Addendum C

Project Name: **LINCOLN COUNTY FIRE PROTECTION DISTRICT, HOUSE NO. 2 BUILDING**

Project Number: **20-1521.00**
Date Issued: **January 3, 2021**

S2.0

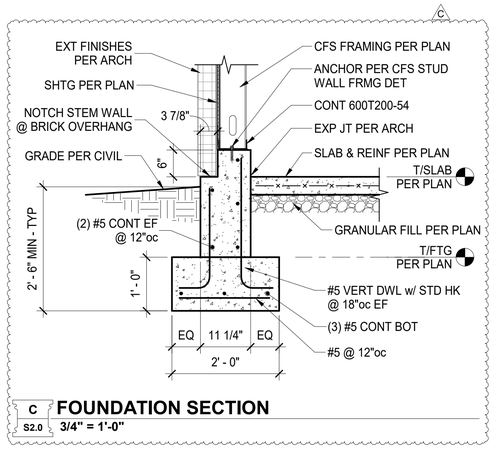
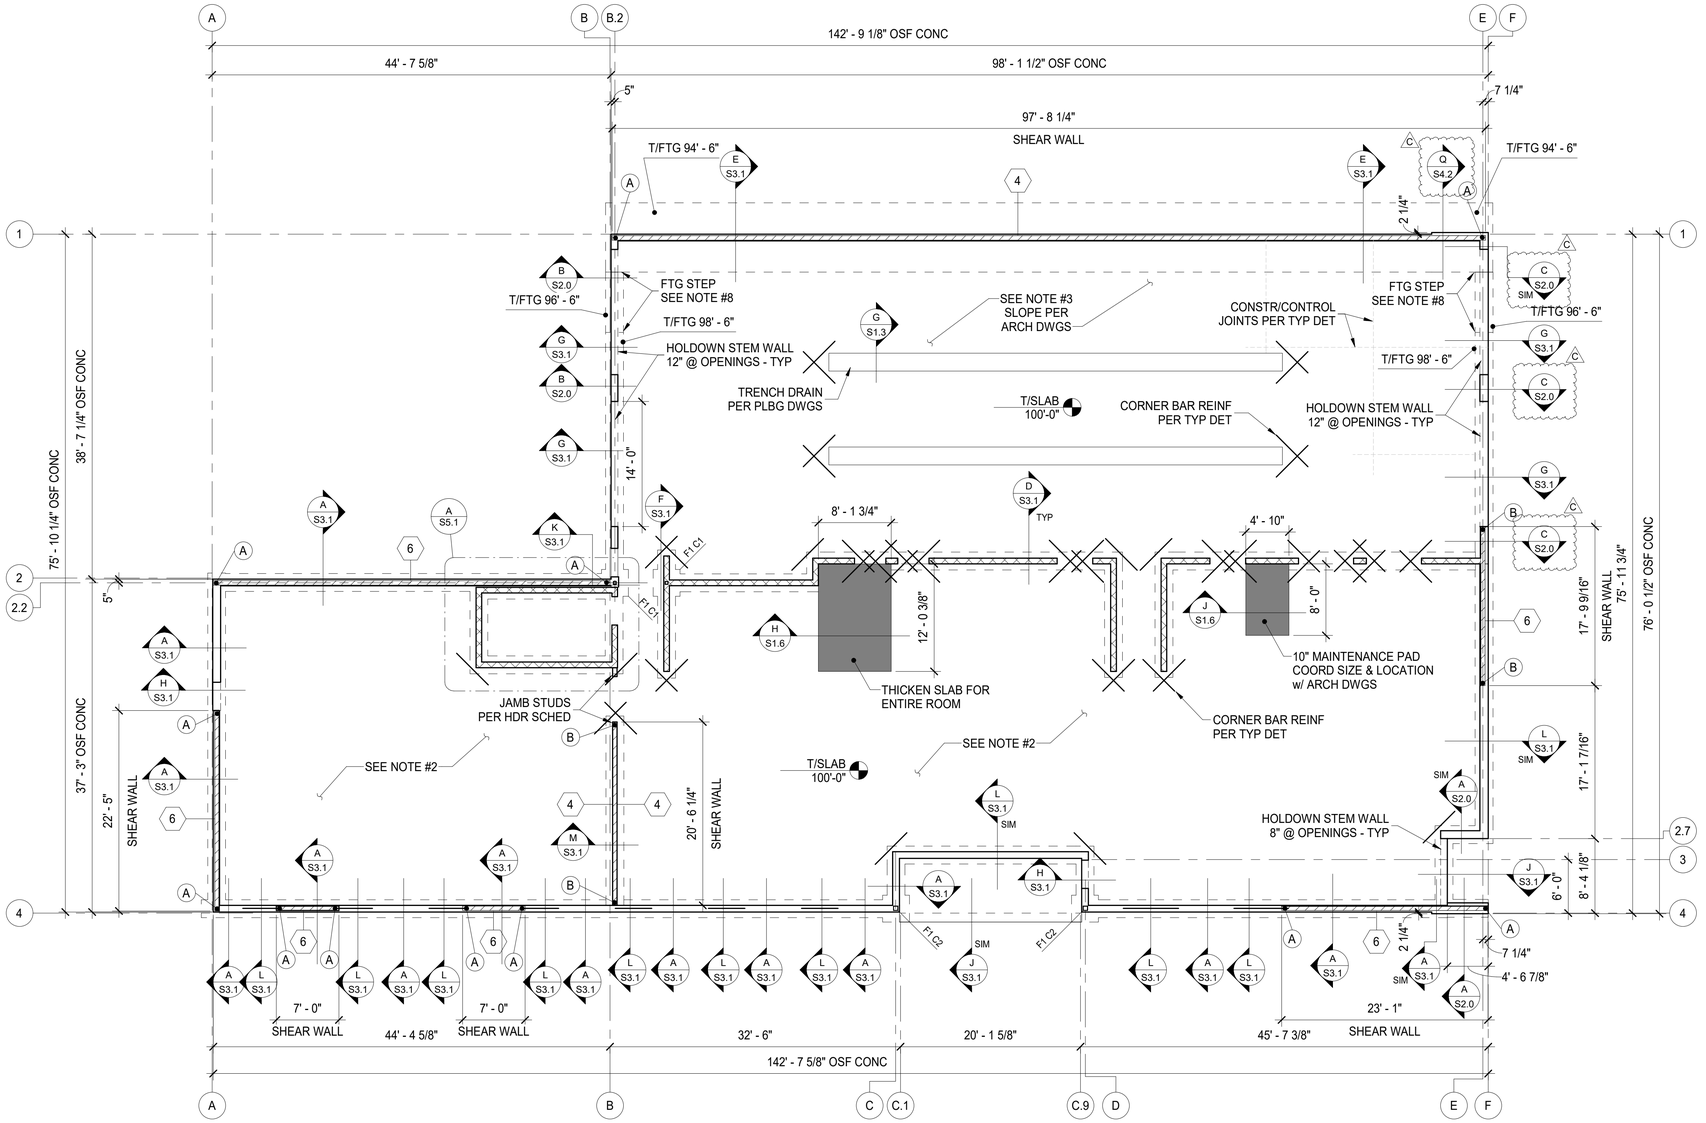
1. S2.0 – Foundation Plan
    a. Added detail C/S2.0 to show notch in stem wall at brick finishes.
    b. Removed 'SIM section' call-out on detail B/S2.0.
    c. Updated plan section call-outs to coordinate with new details.

S3.1

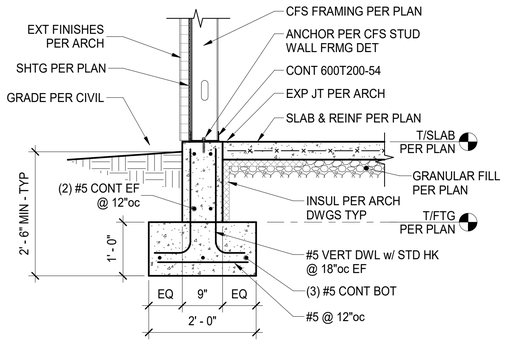
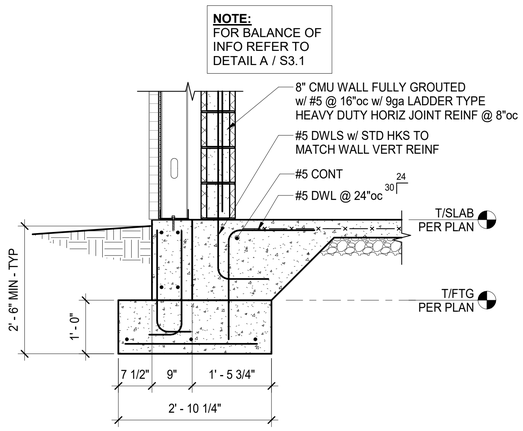
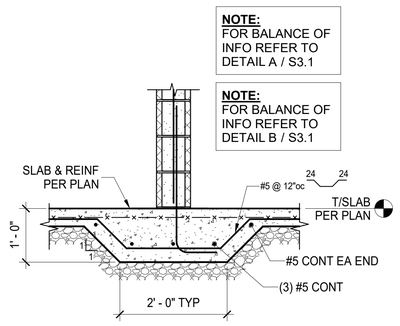
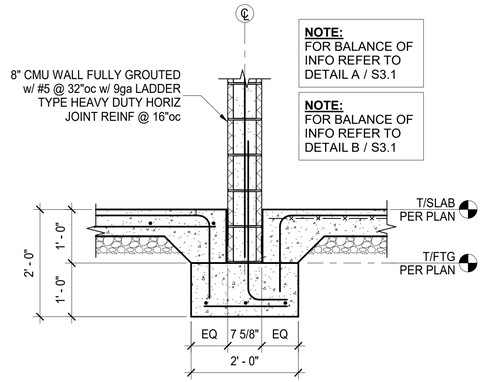
2. S3.1 – Foundation Sections
    a. Removed 'SIM section' call-out on detail E/S3.1

Q S4.2 **FOUNDATION SECTION**
3/4" = 1'-0"

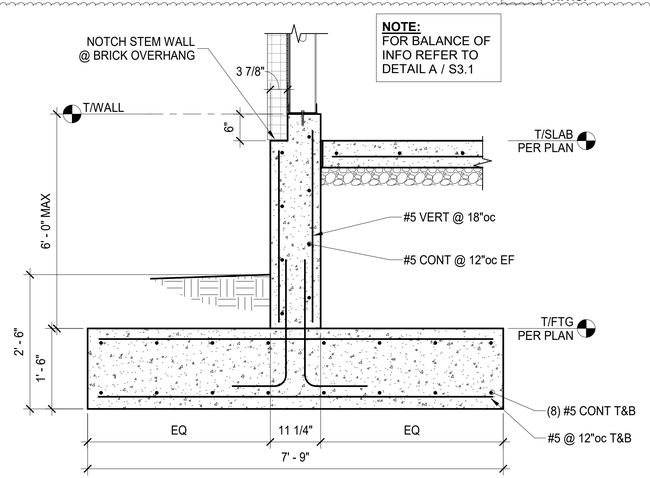
3. S4.2 – Framing Sections
    a. Added Detail Q/S4.2 to show notch in stem wall at brick finishes.

1 P100 WASTE & VENT PLUMBING PLAN

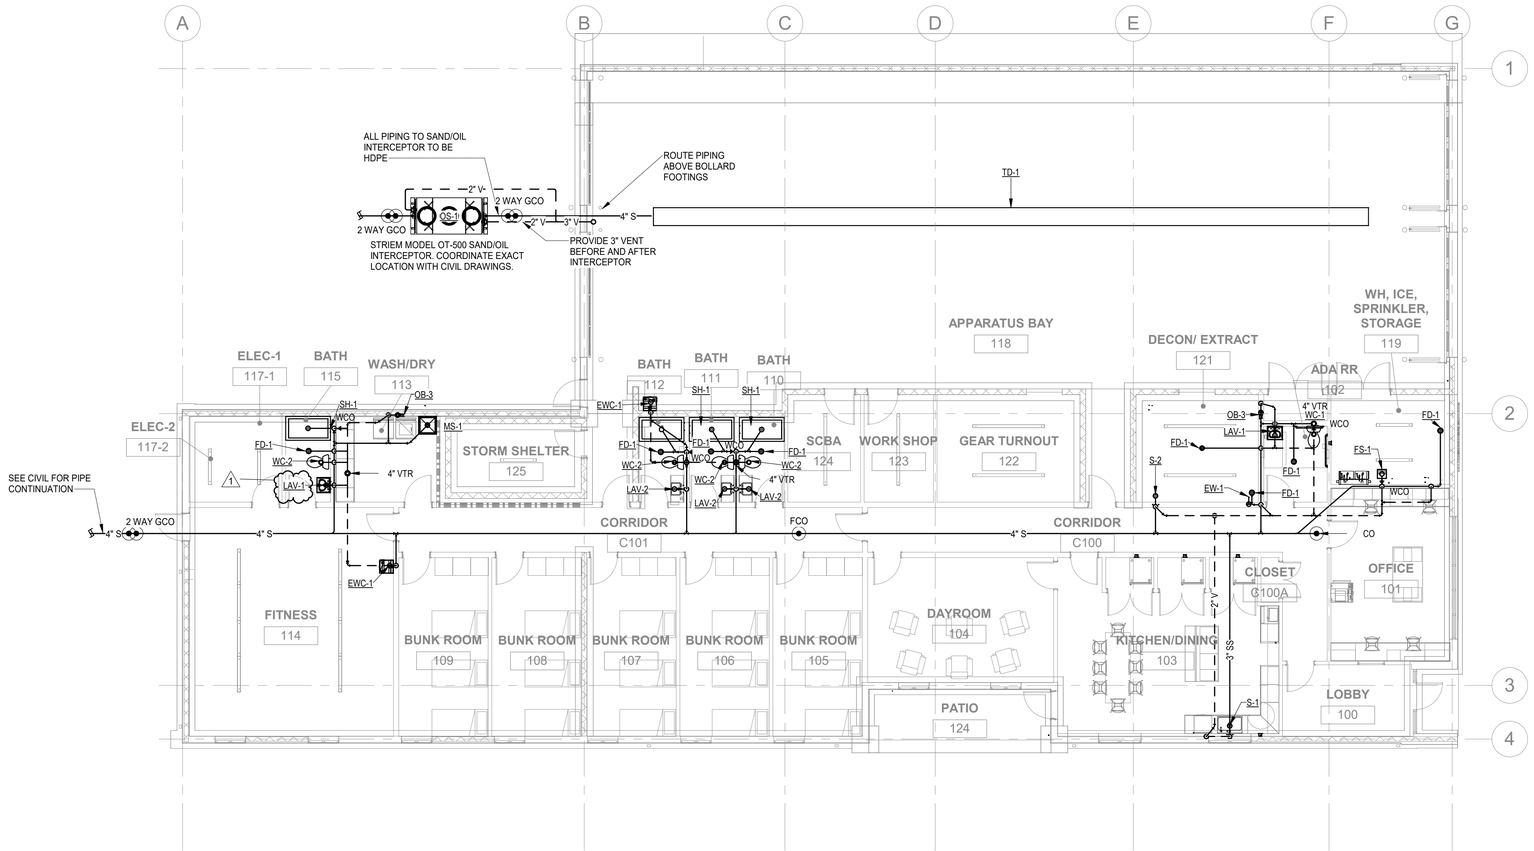
5. P100 – Waste & Vent Plan
    a. Room 115 Lav updated

1 P101 WATER & GAS PLUMBING PLAN

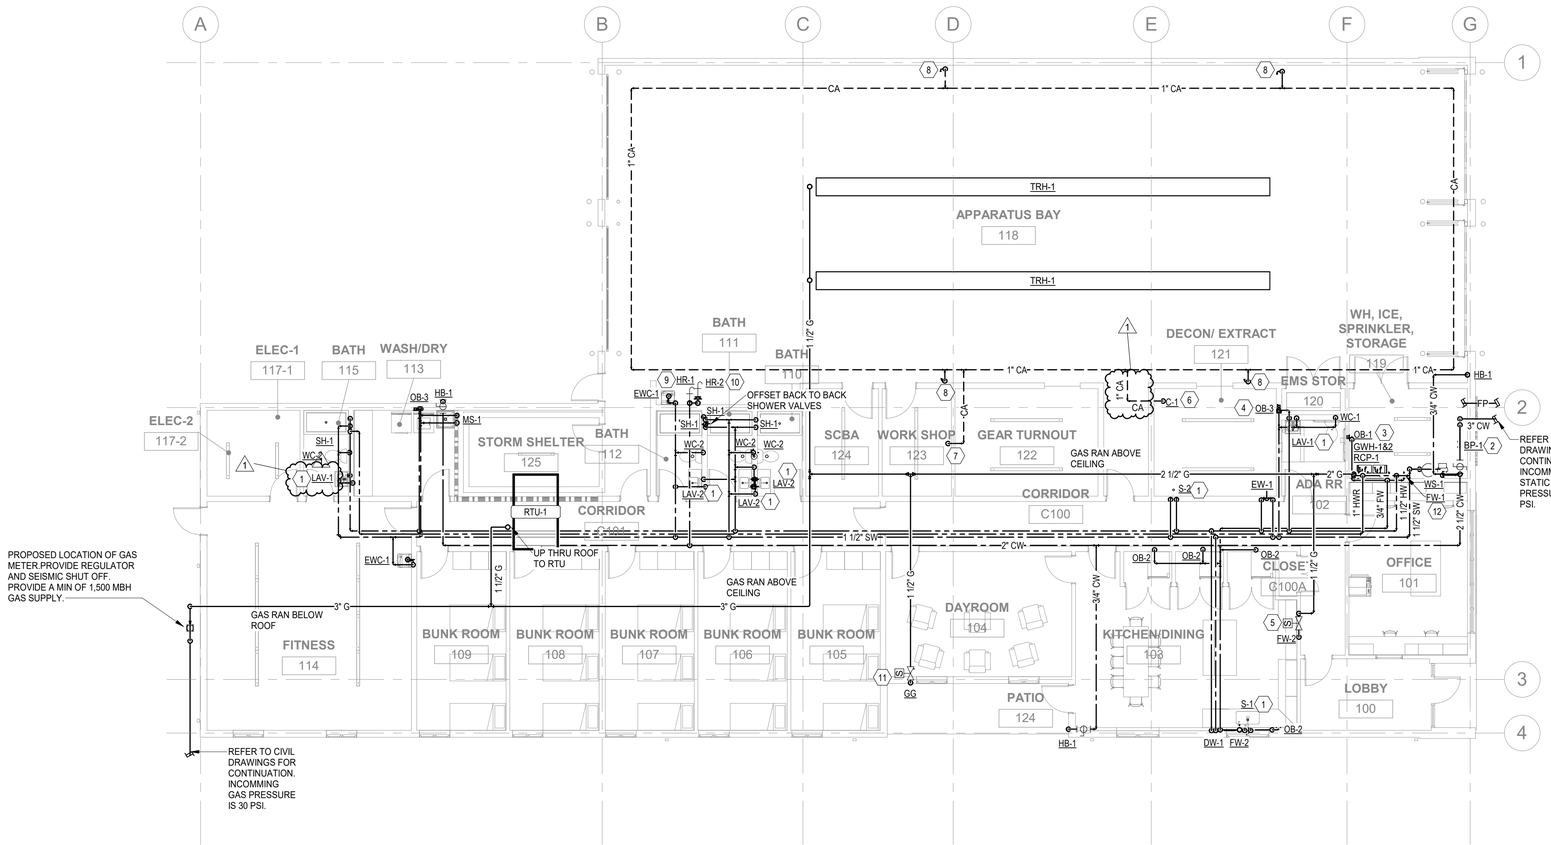
10. *Question: Will copper piping and soldered fittings be acceptable for all sizes of gas piping, including concealed spaces? P001 conflicts with P002 requirement of welded steel greater than 2".*
    Response: Revised to wall hung lav 1.

6. P101- Water and Gas Plan
    a. Room 115 Lav updated

1. They will need to use sch 40 blk steel for all gas piping.
2. Sizes of the SW have been corrected.
3. Refer to addendum response above for shower insert.
4. The HR-1 is to be supplied by owner the HR-2 is just a hose bibb connected, I named it HR-2 so that the location of where it will be installed will be by the other HR location.
5. A provided by list has been added to the plumbing fixture schedule.

2 P300 DOMESTIC WATER RISER

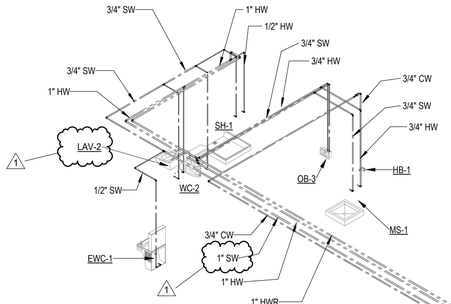
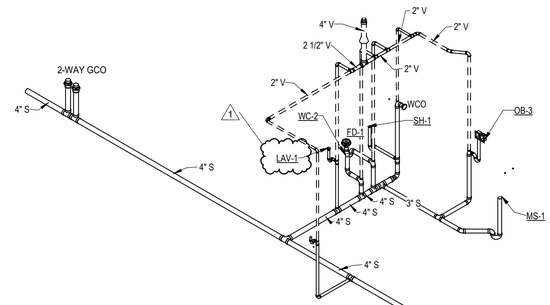
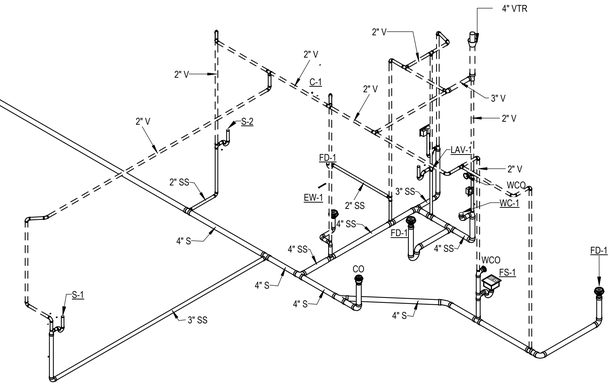
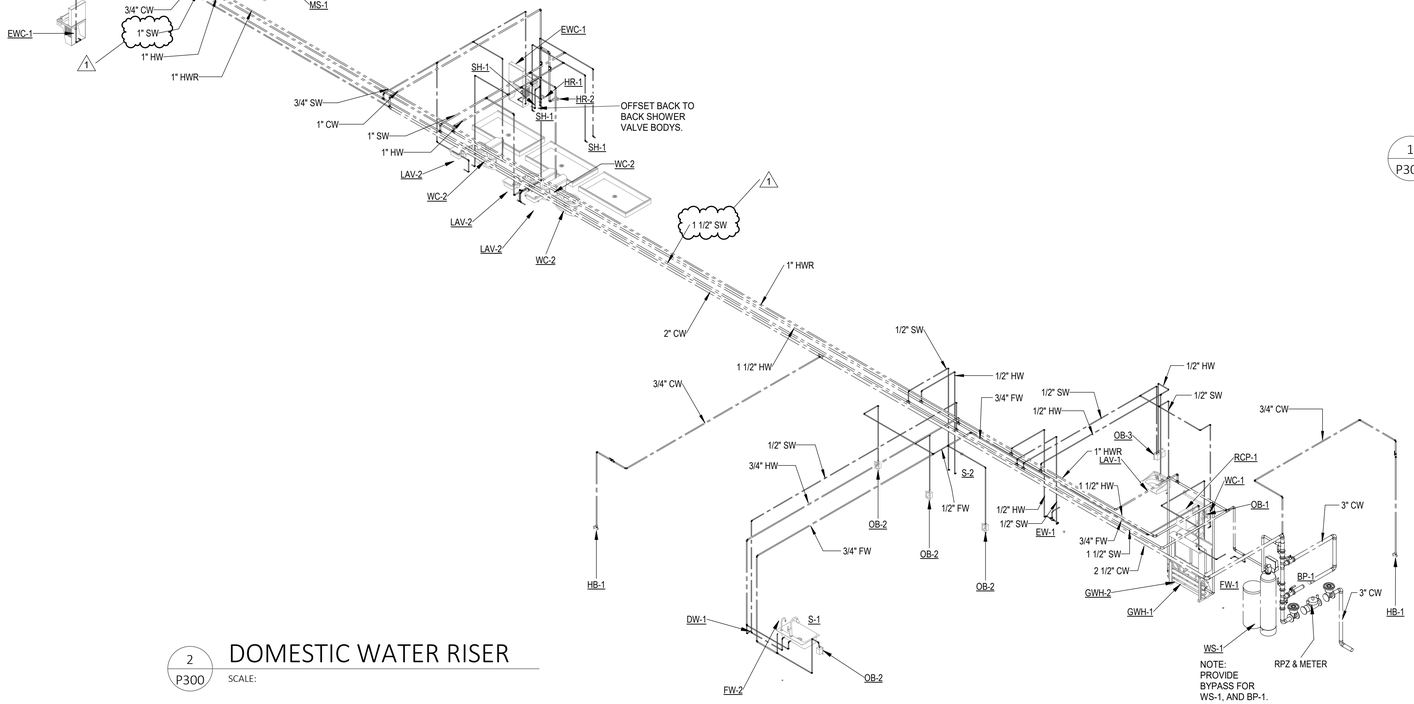
11. *Question: The Soft cold water has conflicting sizing. Overhead and isometric both show 1-1/2" Soft cold leaving the mechanical room. However, down the hallway, it's shown as 2". Please confirm sizing.*
    Response: Revised the soft cold water to the correct size.

7. P300 – Plumbing Isometrics
    a. Diagram Updated

1 E-002 120/208V, 3PH, 4W POWER ONE-LINE DIAGRAM
NO SCALE

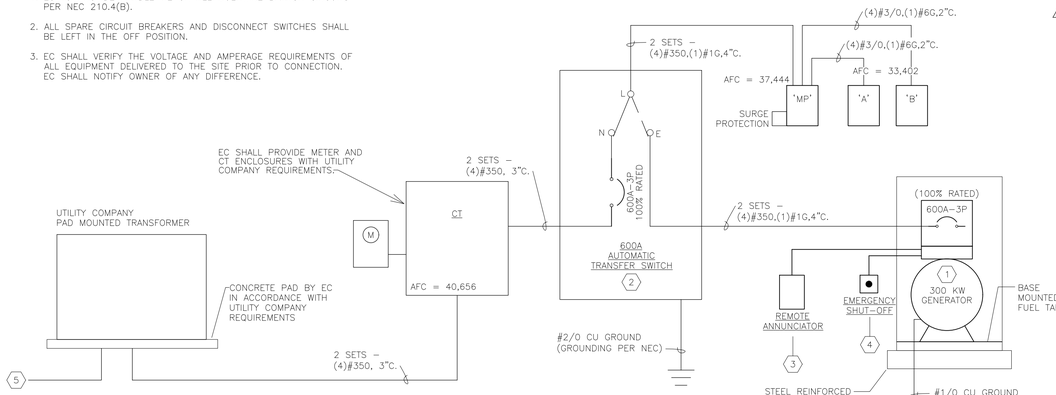
8. *Question: One-line/E-002 shows a 150kW genset but Power Plan/E-300 shows 125kW?*
   Response: Previously sent on 12.16. Will resend with this set.

9. *Question: One-line/E-002 keynote #2 specifies a 400A ATS, 600A is shown on the one-line, and 800A is specified in spec section 263600, 2.1, G, 3?*
   Response: Revised to 600A.

8. E002 – Power One-line & Panel Schedules
    a. Keyed note 2 updated

1. REFER TO SITE PLAN ON SHEET, E101 FOR LOCATION OF EMERGENCY GENERATOR.
2. FURNISH AND INSTALL SERVICE ENTRANCE RATED, AUTOMATIC TRANSFER SWITCH – 120/208V, 600 AMP, THREE–POLE, FOUR–WIRE, WITH A SOLID NEUTRAL, NEMA 3R ENCLOSURE.
3. REFER TO SHEET E–300 FOR LOCATION OF REMOTE ANNUNCIATOR.
4. FIELD VERIFY WITH OWNER LOCATION OF GENERATOR EMERGENCY SHUT–OFF.
5. 4" EMPTY CONDUIT WITH PULLSTRING FOR PRIMARY SERVICE ENTRANCE CONDUCTORS. EXTEND CONDUIT TO UTILITY COMPANY POINT OF SERVICE DELIVERY. PRIMARY SERVICE ENTRANCE CONDUCTORS FURNISHED, INSTALLED AND CONNECTED BY UTILITY COMPANY.

1 E-100 ELECTRICAL LIGHTING PLAN
1/16" = 1'-0"

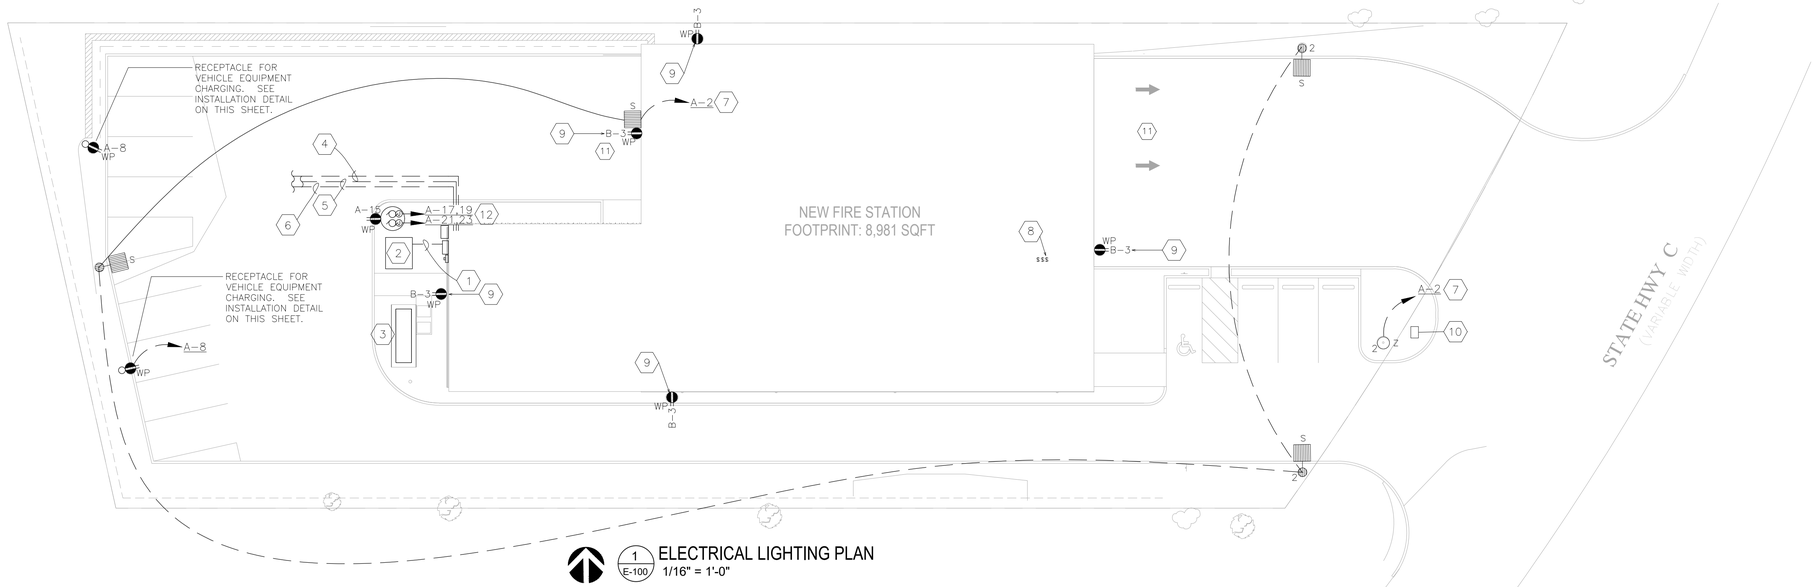
7. *Question: Note 11 on sheet E-100 calls for snow melting cabling in concrete. It refers you to the specification's but I cannot find anything in the specs about it.*
   Response: Refer to E-100 for Snow Melt System bid alternate.

14. *Question: We wanted to submit an additional RFI regarding the snow melt system that is indicated by note 11 on page E100. Per the note, additional information is contained within division 26 specifications. However, in looking through the specs, we were not able to find any information regarding the snow melt system. At your convenience, would you be able to provide all available information about the snow melt system, such that we can include this in our bid?*
    Response: Refer to revised E-100 for more information.

9. E100 – Electrical Site Plan
    a. Snow Melt Bid Alternate information added to drawing.

BID ALTERNATE FOR SNOW MELT SYSTEM: 3

Bid alternate shall include all costs associated with providing a snow melt system at a portion of the front drive.

Provide two (2) 50 Amp, 2-pole GFCI circuit breakers (30 mA type) for power supply to the snow melt system for operation at 208 Volts, single-phase.

Power supply conductors to each controller shall be (2) #8, (1) #10G - ¾" C.

The heating cable shall be protected from damage where it leaves the pavement to the junction box with 1 inch galvanized rigid conduit. Provide one (1) conduit for each heating cable.

1 E-300 ELECTRICAL POWER PLAN
1/8" = 1'-0"

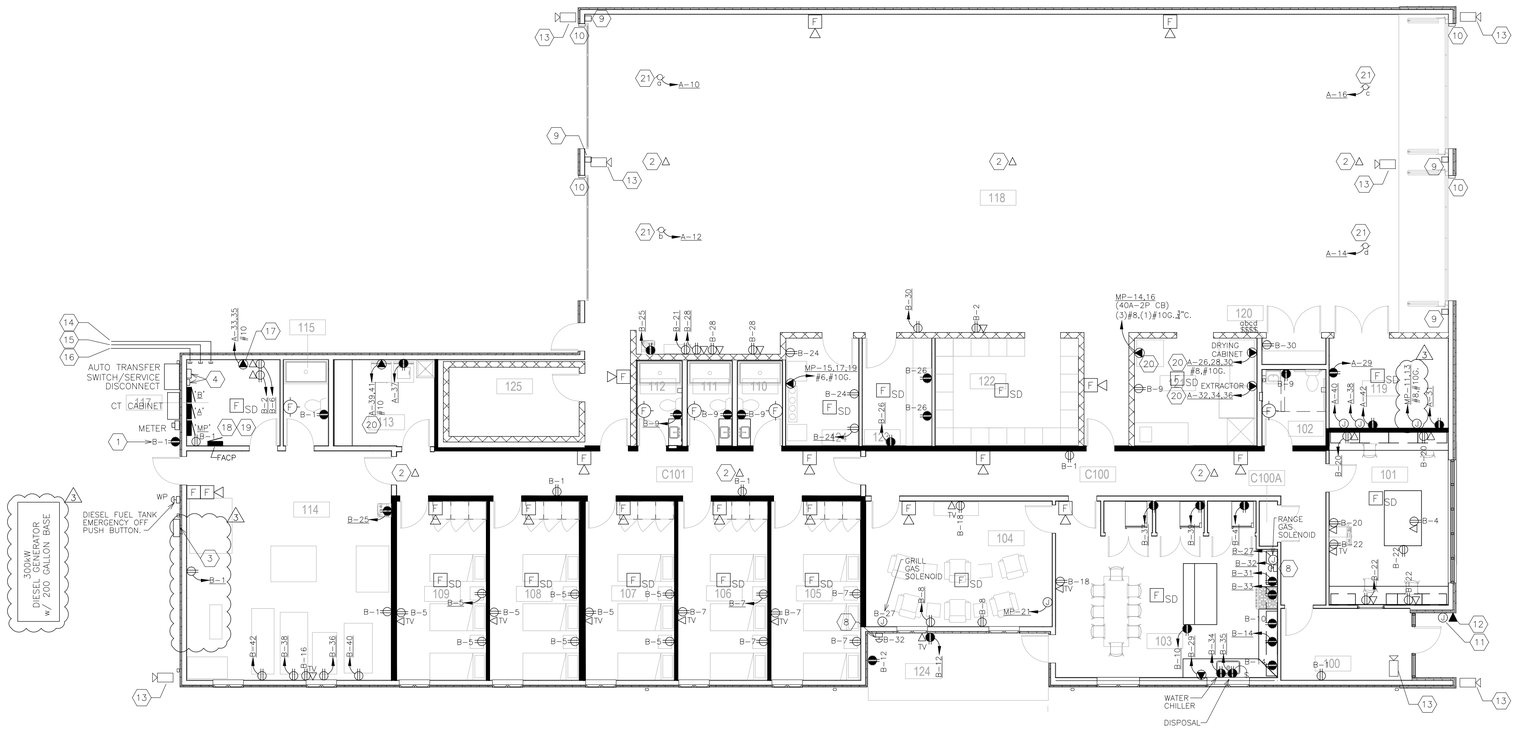
4. *Question: Note 9,10 on sheet E-300 talks about a signal warning light that ties into the overhead door system. Will the garage door company be supplying this item?*
   Response: EC to provide

10. E300 – Electrical Power Plan
    a. See plan and updated keyed note 3

3. LOCATION OF REMOTE ANNUNCIATOR FOR 300kW GENERATOR.
4. WALL MOUNTED MEDIA LOCATION. MOUNT DUPLEX RECEPTACLE, (1) COAX, AND (1) DATA OUTLET. PROVIDE (1) CAT 6 CABLE FOR DATA OUTLET BACK TO DATA RACK IN IT CLOSET. PROVIDE (1) COAX CABLE FOR COAX JACK BACK TO COAX DEMARCATION POINT.
